Request for Additional Information No. 34 Supplement 1, Revision 0

U. S. EPR Standard Design Certification

AREVA NP Inc.

Docket No. 52-020

Figure 15.2-65—FWLB Representative Small Break – RCS Maximum Pressure

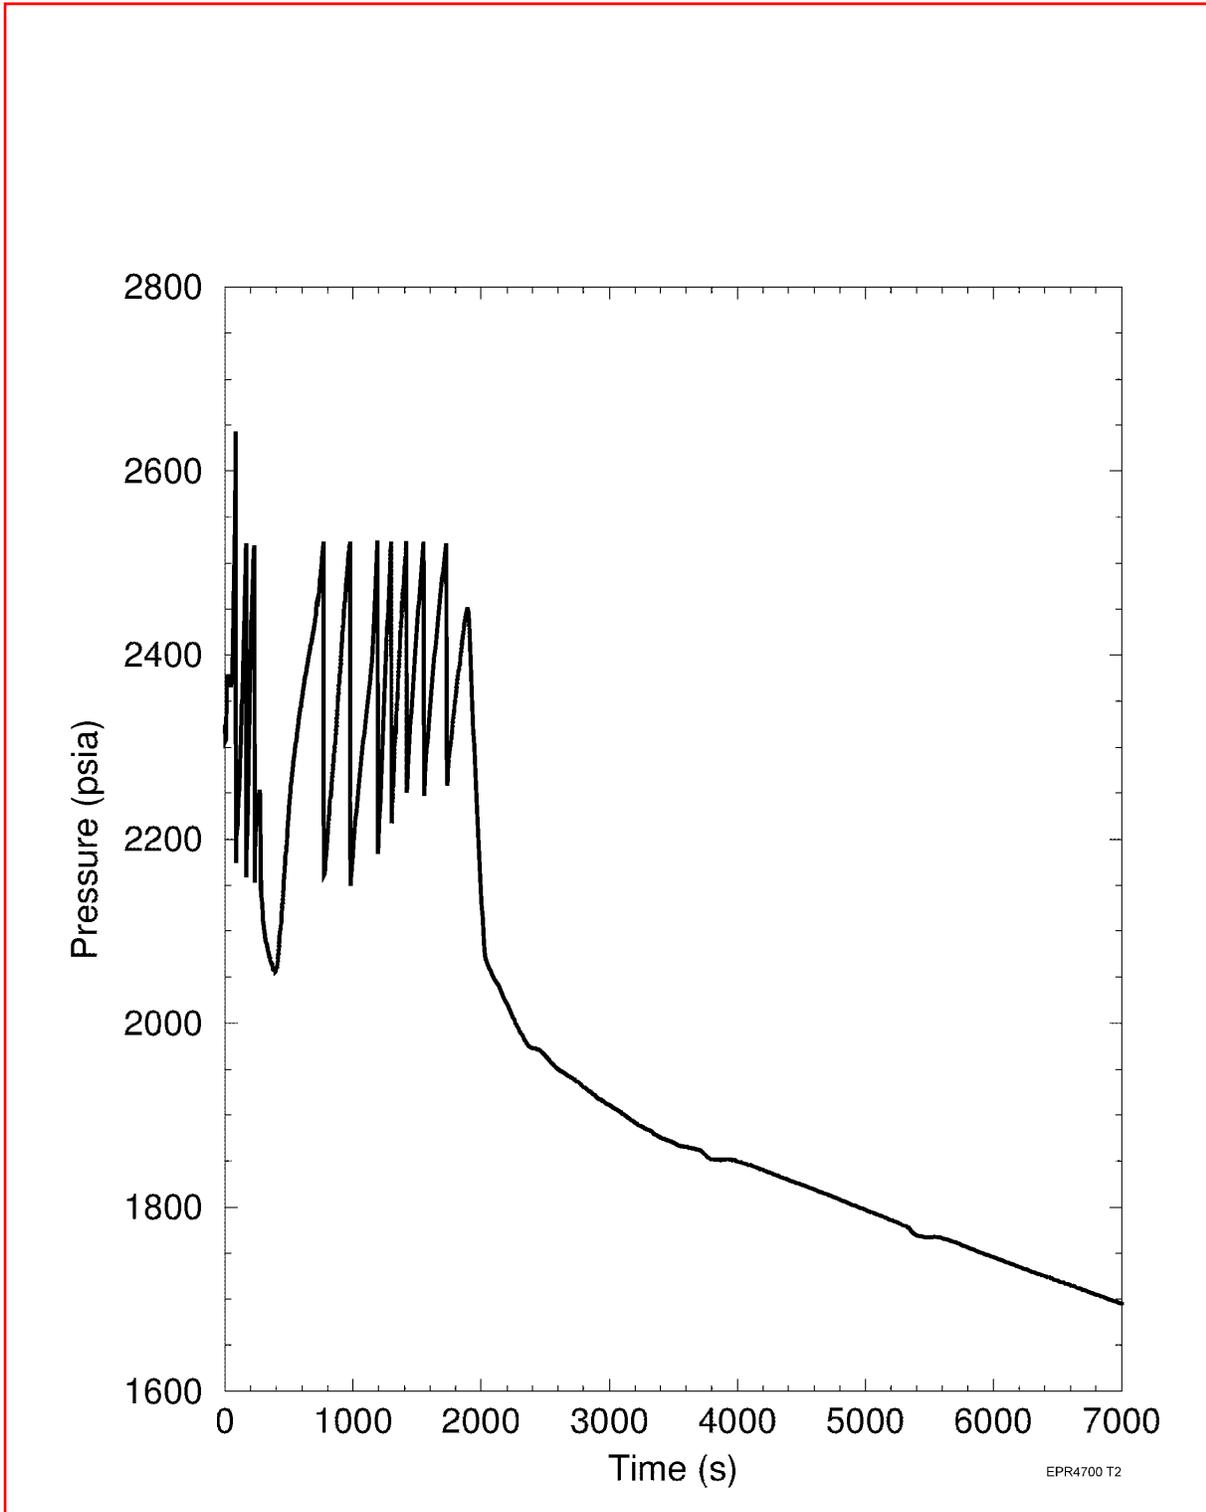
Figure 15.2-50 “FWLB Representative Small Break - Pressurizer Pressure” shows a predicted pressure range, which is above 1,600 psia till the end point of analysis at 7,000 s. Figure 15.2-65 “FWLB Representative Small Break – RCS Maximum Pressure” reveals a predicted pressure range that is below 1,500 psia from the beginning of the analysis at 0 s. Please explain the difference (15.2.8 Section III).

The U.S. EPR FSAR figures identified above and in RAI Questions 15.02.08-5, 15.02.08-6, 15.02.08-7, 15.02.08-8, and 15.02.08-10 are incorrect. U.S. EPR FSAR, Tier 2, Figure 15.2-65—FWLB Representative Small Break – RCS Maximum Pressure, Figure 15.2-66—FWLB Representative Small Break – Steam Generator Maximum Pressure, Figure 15.2-67, Figure 15.2-68, and Figure 15.2-69 will be replaced.

Figure 15.2-66—FWLB Representative Small Break – Steam Generator
Maximum Pressure

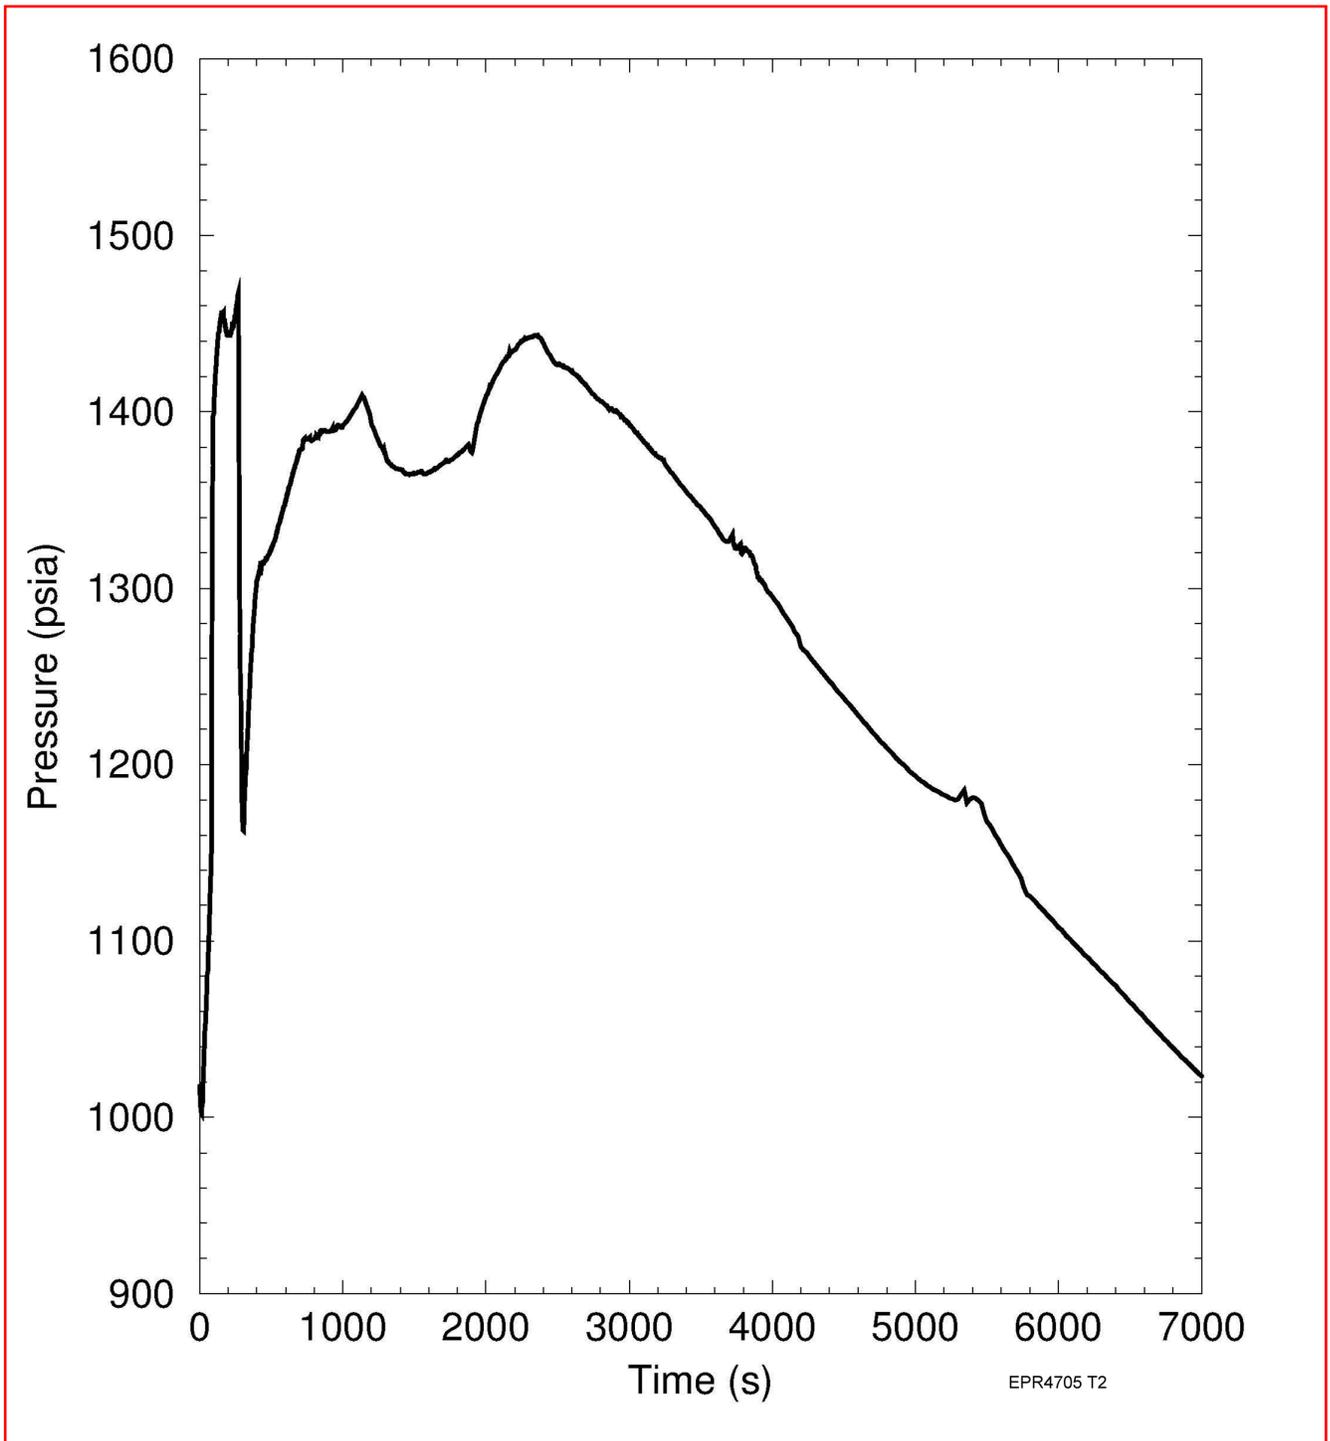
Figure 15.2-66 “FWLB Representative Small Break – Steam Generator Maximum Pressure” shows reactivity quantities plotted in units of \$. Please clarify the unit. (15.2.8 Section III).

Figure 15.2-67—FWLB Representative Small Break – Reactivities

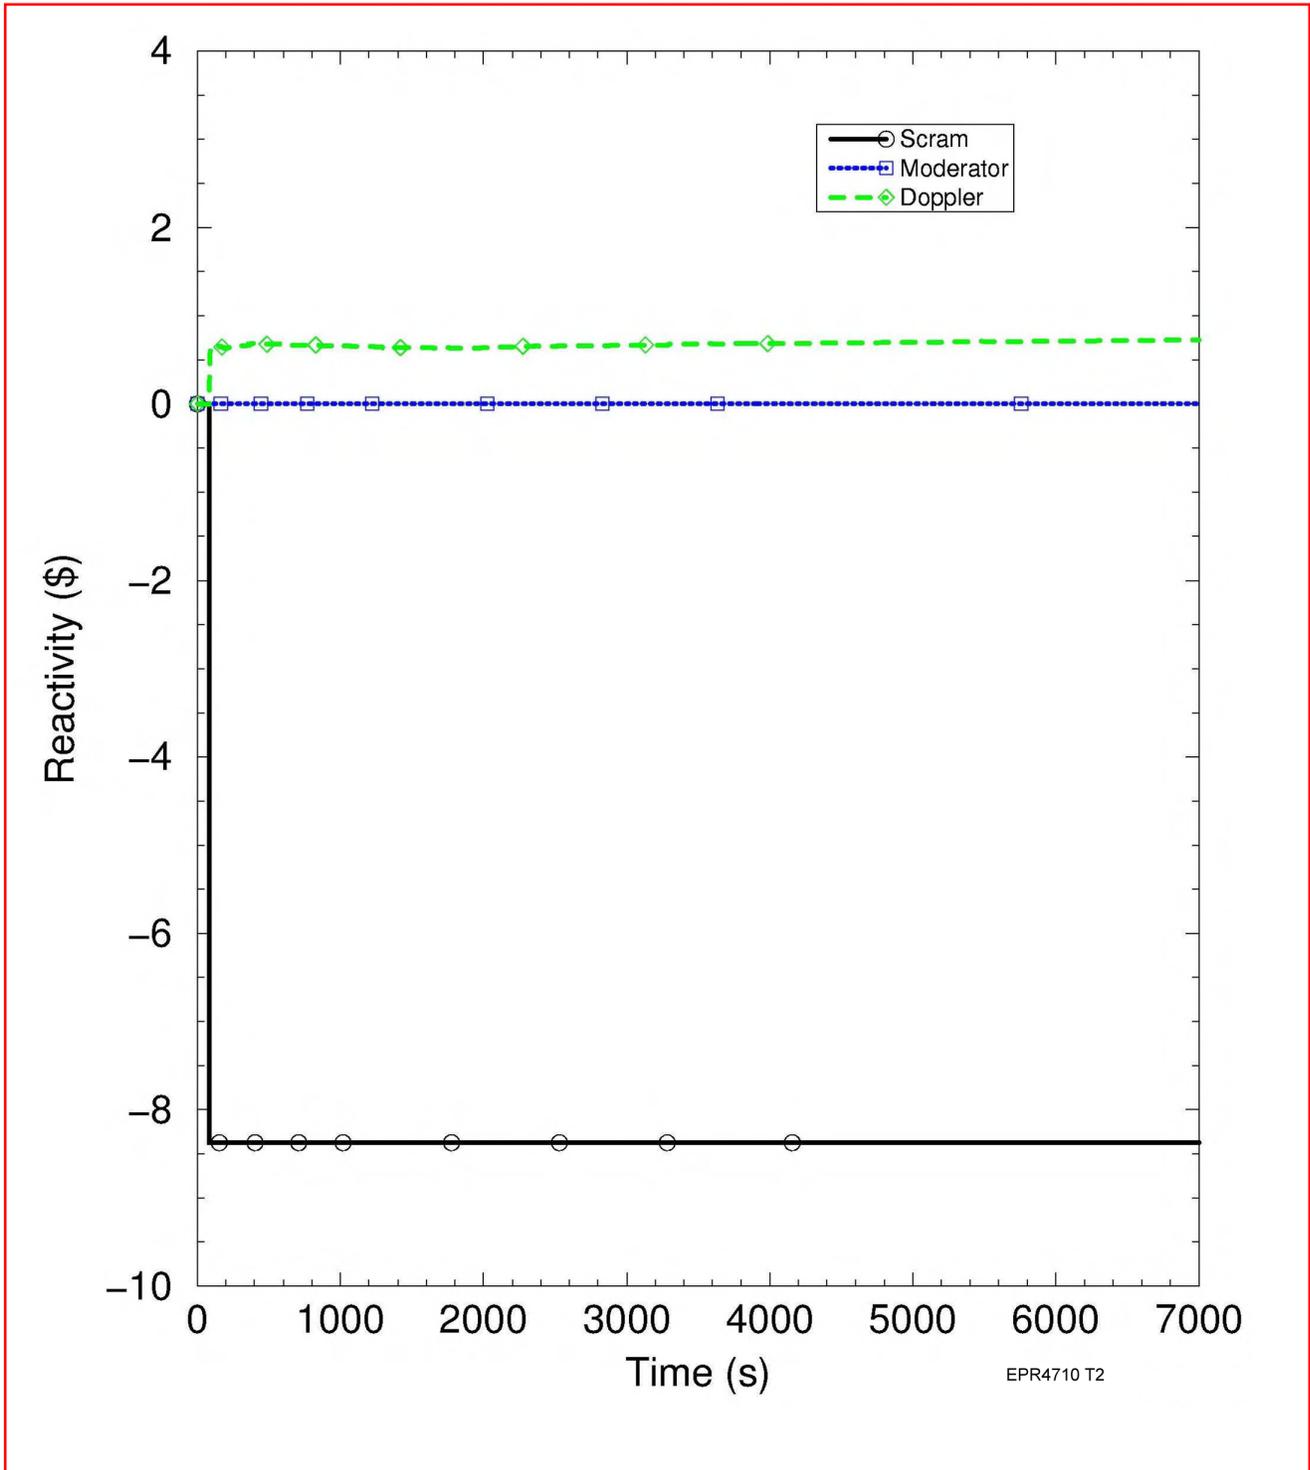
Figure 15.2-67—FWLB Representative Small Break – “Reactivities shows liquid fraction vs time”. Figure 15.2-68—“FWLB Representative Small Break – Liquid Volume Fraction in Pressurizer Dome” shows power vs time. Figure 15.2-69—“FWLB Maximum RCS Pressure Case – Reactor and Total Steam Generator Power shows pressure vs time”. Please explain the discrepancies between the titles and the parameters presented in the transient curves.

Figure 15.2-67 “FWLB Representative Small Break – Reactivities” shows a liquid fraction quantity in dimensionless units. Please clarify the unit. (15.2.8 Section III).

Figure 15.2-68—FWLB Representative Small Break – Liquid Volume Fraction in Pressurizer Dome

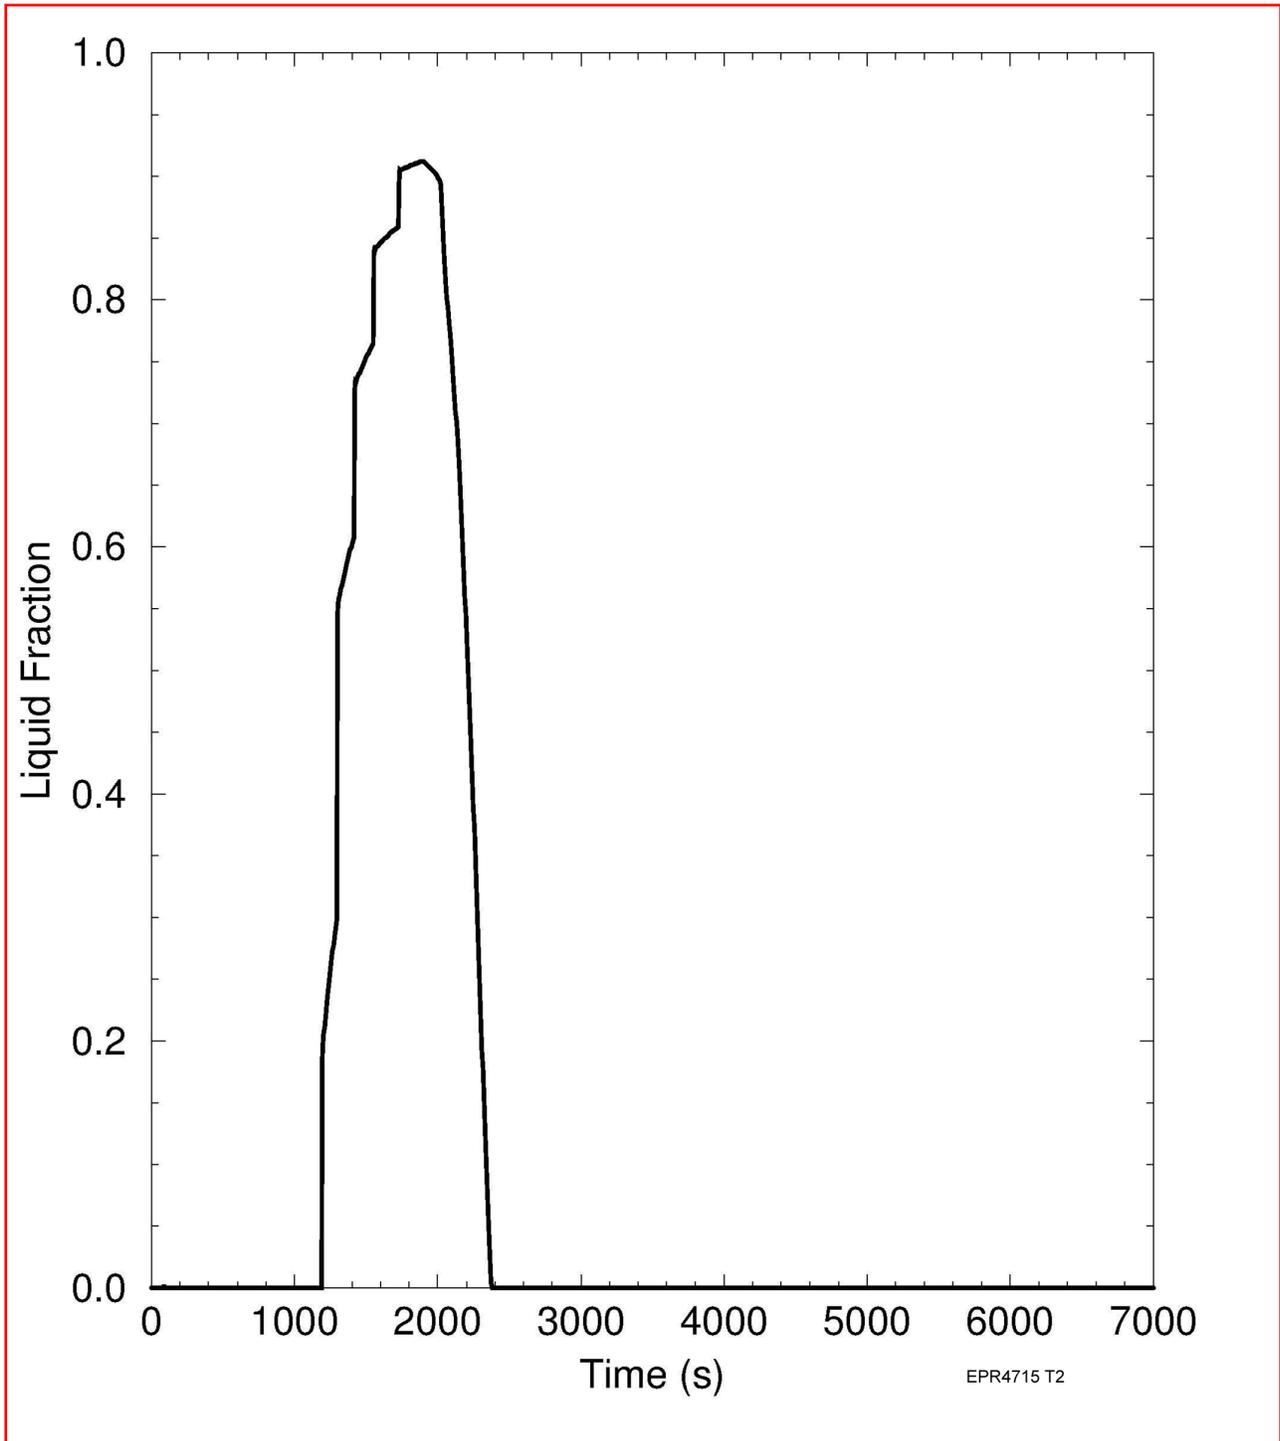
Figure 15.2-68 “Representative Small Break – Liquid Volume Fraction in Pressurizer Dome” shows quantities in units of MW. Please clarify the unit. (15.2.8 Section III).

Figure 15.2-69—FWLB Maximum RCS Pressure Case – Reactor and Total Steam Generator Power

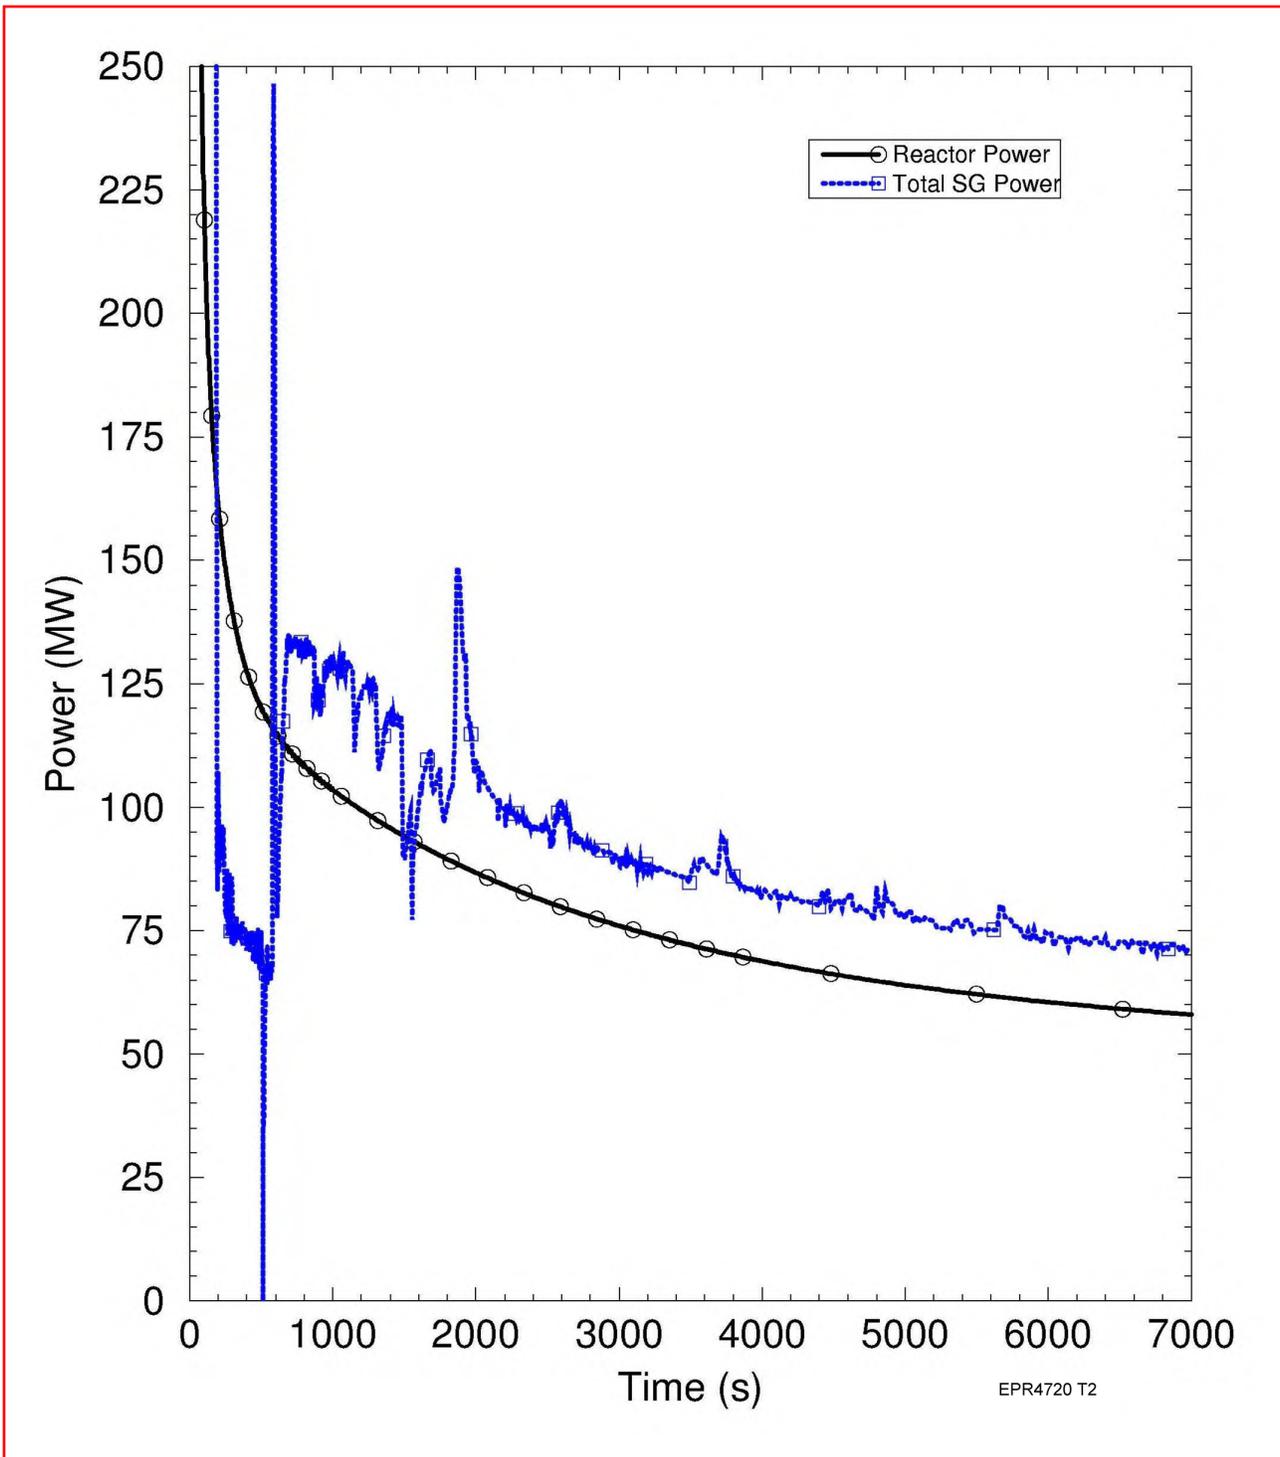
Figure 15.2-69 “FWLB Maximum RCS Pressure Case – Reactor and Total Steam Generator Power” shows a quantity in psia units. Please clarify the unit. (15.2.8 Section III).

Figure 15.6-93—IOPSRV - Representative Plot of Minimum Normalized Minimum DNBR and Maximum LPD Normalized to the SAFDL

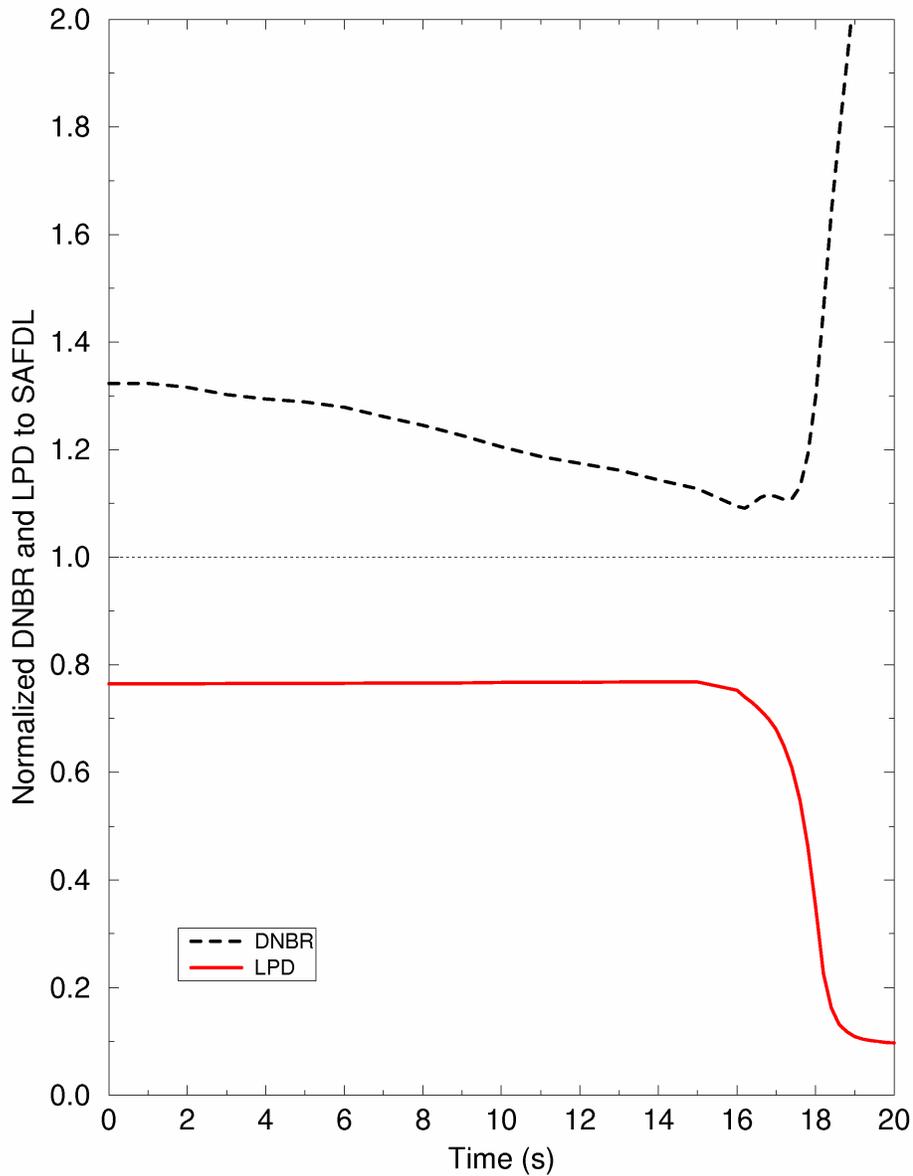
Provide the DNBR as a function of time for all Chapter 15.6 analyses for which it is a key parameter.

A representative plot of the minimum departure from nucleate boiling ratio (DNBR) and maximum linear power density (LPD) to their respective specified acceptable fuel design limit (SAFDL) is shown in the enclosed new U.S. EPR FSAR, Tier 2, Figure 15.6-93 (IOPSRV – Representative Plot of Minimum Normalized Minimum DNBR and Maximum LPD Normalized to the SAFDL) for the inadvertent opening of a pressurizer safety relief valve (IOPSRV) event.

In the new figure, the line indicated as LPD is the calculated LPD, including all applicable uncertainties, normalized to either the fuel centerline melt (FCM) or clad strain limit (whichever is more limiting). For anticipated operational occurrence (AOO) events, the limiting LPD of clad strain is more limiting and is therefore used to provide the normalized LPD. The LPD SAFDL is designed to protect both the FCM and clad strain limits as discussed in U.S. EPR FSAR, Tier 2, Section 15.0.0.3.9.
